NEW MEXICO OIL CONSERVATION COMMISSION

SUNDRY NOTICES AND REPORTS ON WELLS
(DO NOT USE THIS FORM FOR PROPOSALS TO DRILL OR TO DEEPEN OR PLUG BACK TO A DIFFERENT RESERVOIR. USE "APPLICATION FOR PERMIT -" (FORM C-101) FOR SUCH PROPOSALS.)

Manana Gas, Inc. - Cook # 1-E

Deviation Needed to Drill to an Orthodox Location

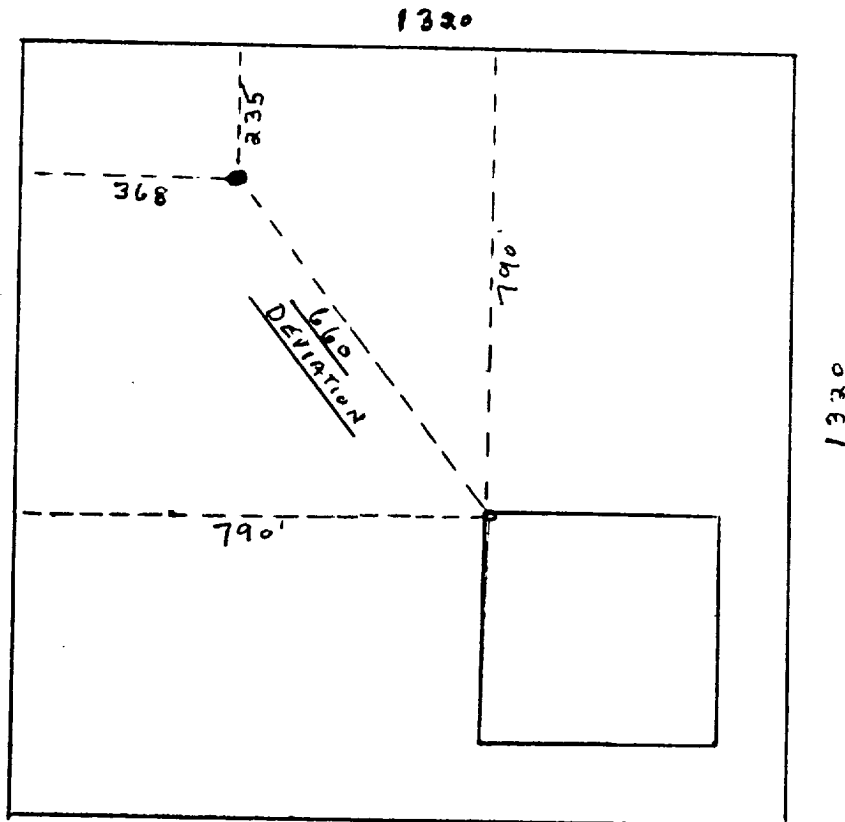
Due to objections raised by an offset operator this well will be drilled with a sub-surface deviation to the southeast so that the bottom of the hole will be at a standard location of 790 FNL and 790 FWL of Section 22-29N-11W.

Deviation plat attached.

$$\frac{660}{6500} = 10.15\% \text{ DEVIATION}$$

SAY 700' DEVIATION

Apply for permission per Rule 111 (c) (d) (e)
